5.1 APPLICATION TO AMEND A DEVELOPMENT PLAN - POD/1/2007/J 1056-1140 & 1142 PLENTY ROAD, BUNDOORA

Property:	1056-1140 & 1142 Plenty Road, Bundoora
Proposal:	<p>Amendment of Development Plan (POD/1/2007) as it relates to this site address, including:</p> <ul style="list-style-type: none"> Introduce residential land uses to both north and south buildings. Increase the height of the Northern Building (1B-02) from 5 to 6 storeys to 7 to 8 storeys. Increase the height of the Southern Building (1B-01) from 8 to 9 storeys to 9 to 10 storeys.
Car parking:	Two to three levels of basement car parking.
Zoning and Overlay/s:	<ul style="list-style-type: none"> Mixed Use Zone (MUZ) Development Plan Overlay – Schedule 1 (DPO1) Development Contributions Plan Overlay (DCPO)
Is a Developer Contribution required?	No. A Developer Contribution is not directly associated with this matter (but should be applicable to any future planning permit issued).
Council 100YR Flooding:	Yes
Consultation:	<ul style="list-style-type: none"> Non-statutory notice - Letters were sent to surrounding owners and occupiers as informal notice.

Recommendation	Refuse the proposed amendment to the Development Plan.

Polaris Precinct 1B - Indicative Section Diagrams
FIGURE 57a

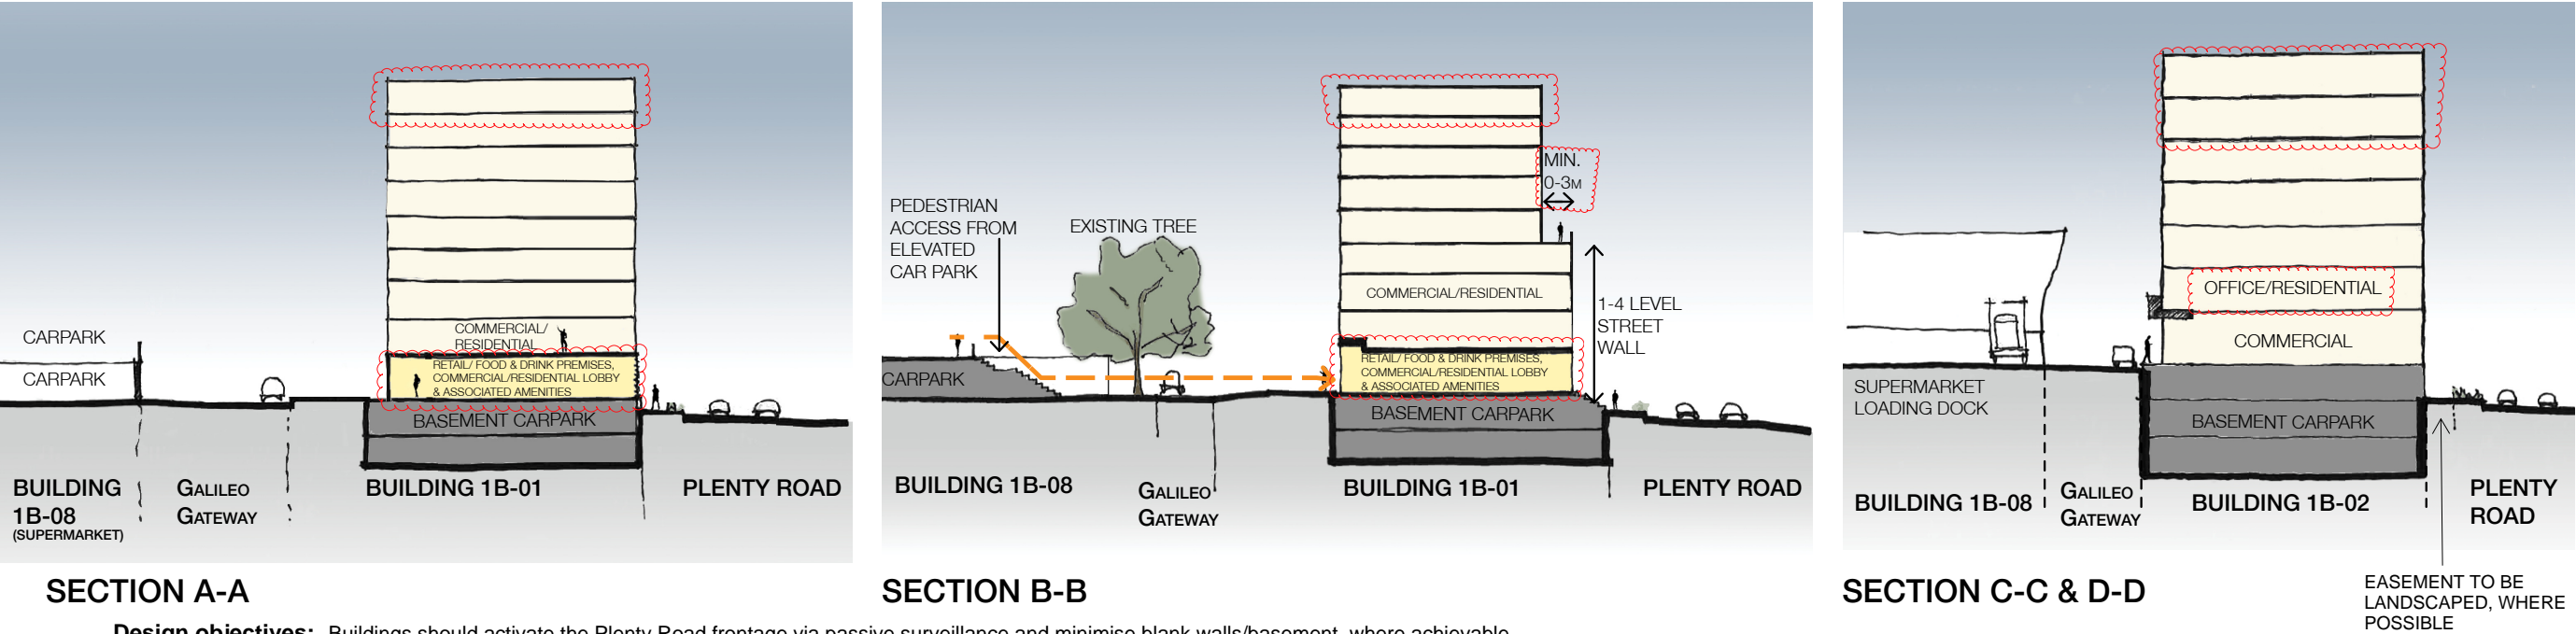
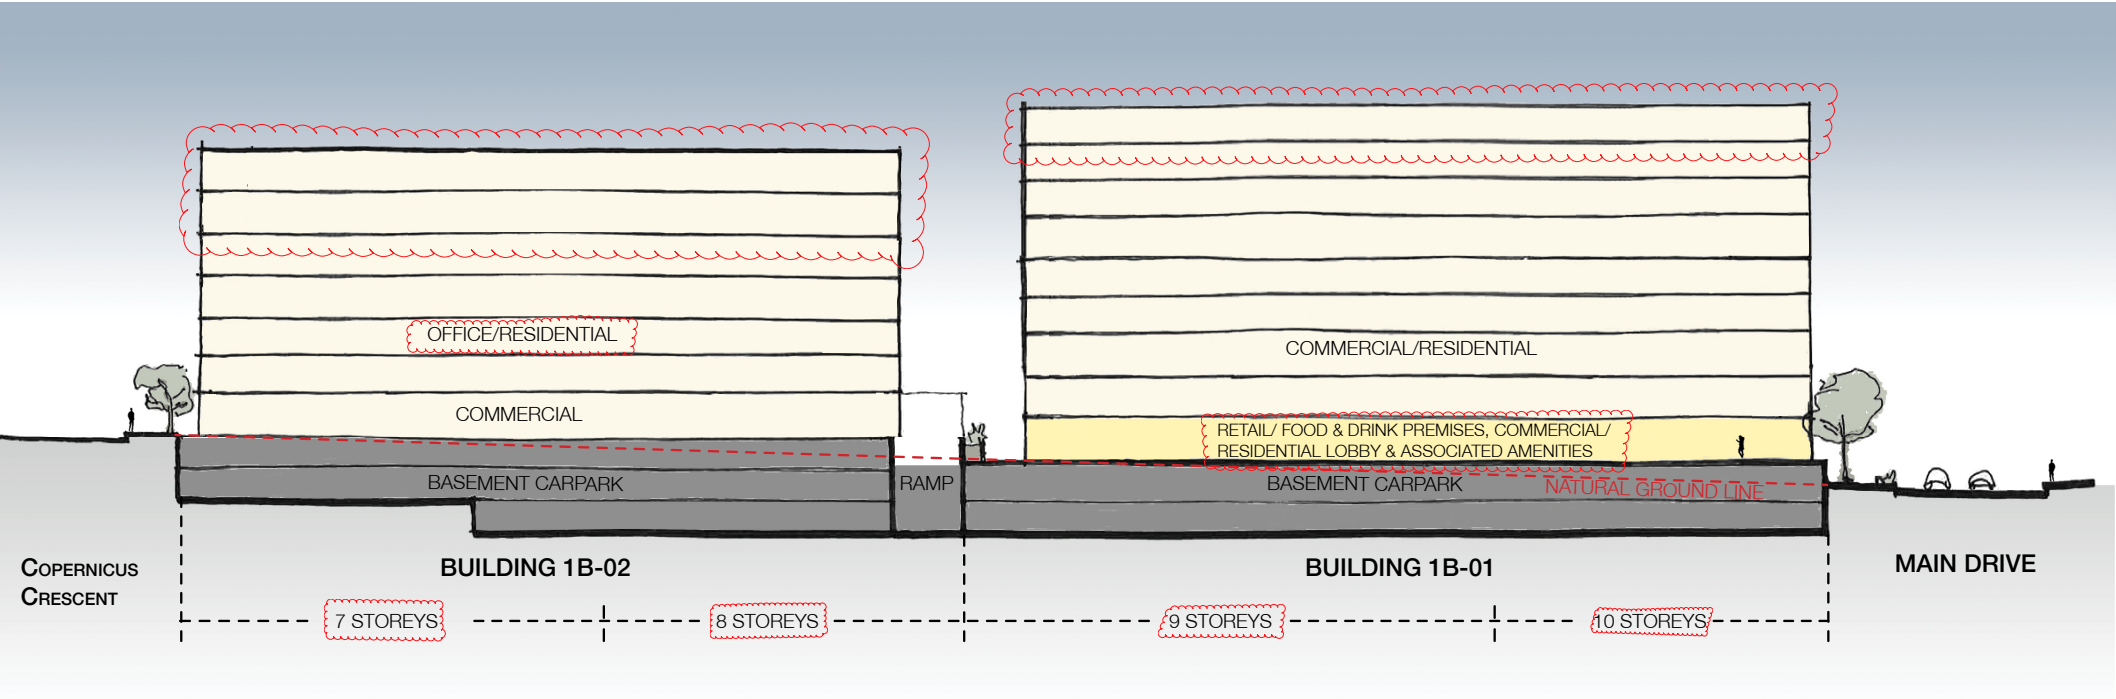
<p>of the proposal, and so does not give any indication of how materials might be provided above a street wall which is now proposed.</p>	
<p>An overall scheme for landscape development including the location, spread, height, species and proposed irrigation system for all existing and proposed planting.</p>	<p>The overall masterplan includes vegetation within the site along Main Drive and along Galileo Gateway:</p>  <p>The proposed sections then put the Main Drive vegetation off of the site:</p>  <p>The Landscape Concept Plan then includes planting within the site on Main Drive again, along Galileo Gateway and also within a landscaped setback to Plenty Road:</p>	<p>40, 43a, 60</p>

Figure 86 Indicative Conceptual Building Heights above ground (ie storeys)

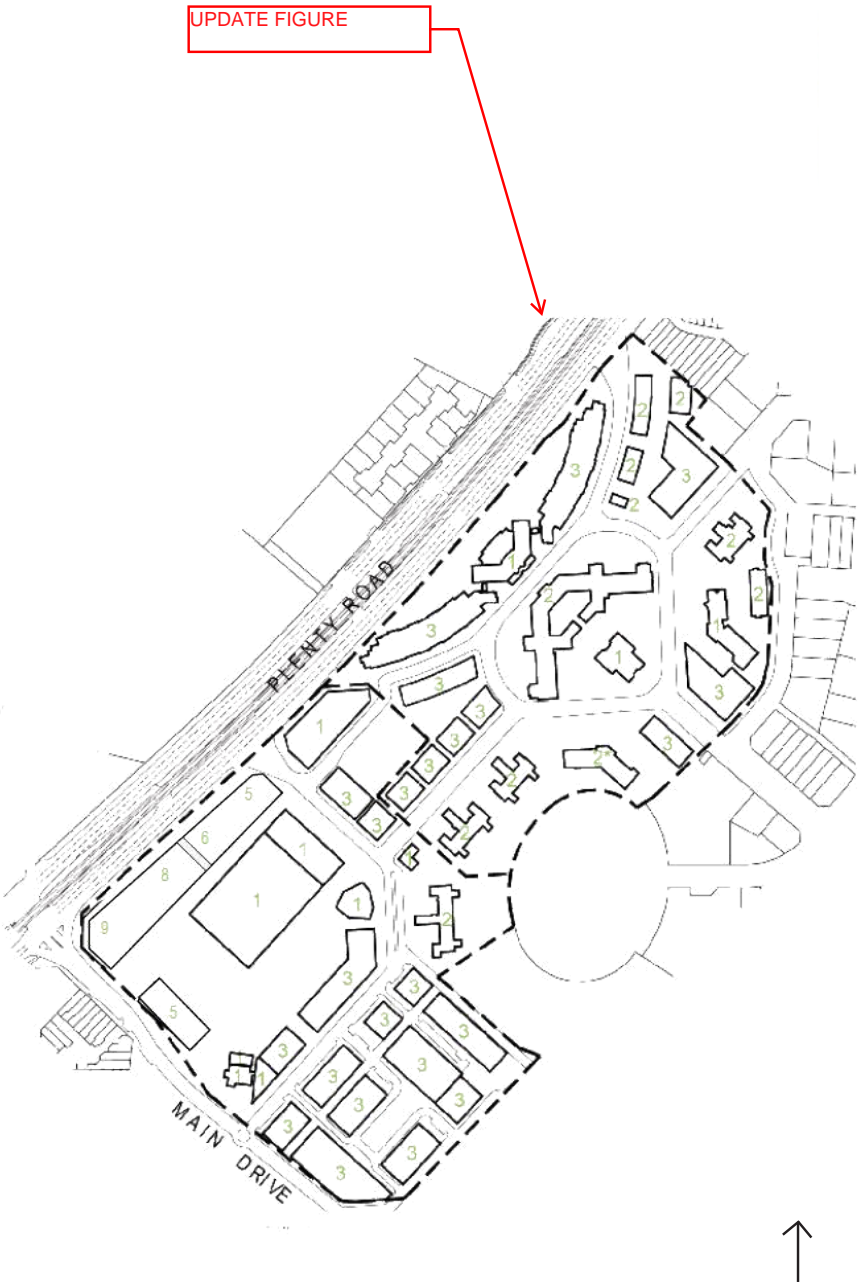
Urban design guidelines.	Urban design guidelines are provided at Section 4.7. The Guidelines conflict substantially with other portions of the plan. They state there <i>'is an opportunity for building height up to 8-9 storeys for building 1B-01 (southern building) and 5-6 storeys for Building 1B-02' (northern building)</i> . This conflicts with the subsequent Section 5.3.4. statement that greater heights than these are suitable. The guidelines also indicate that the Main Street Frontage setback should be at least 2 metres for residential buildings while separately indicating no setback for the potentially residential portion of the building. Due to these inconsistencies the guidelines do not properly address the information requirements.	53, 82
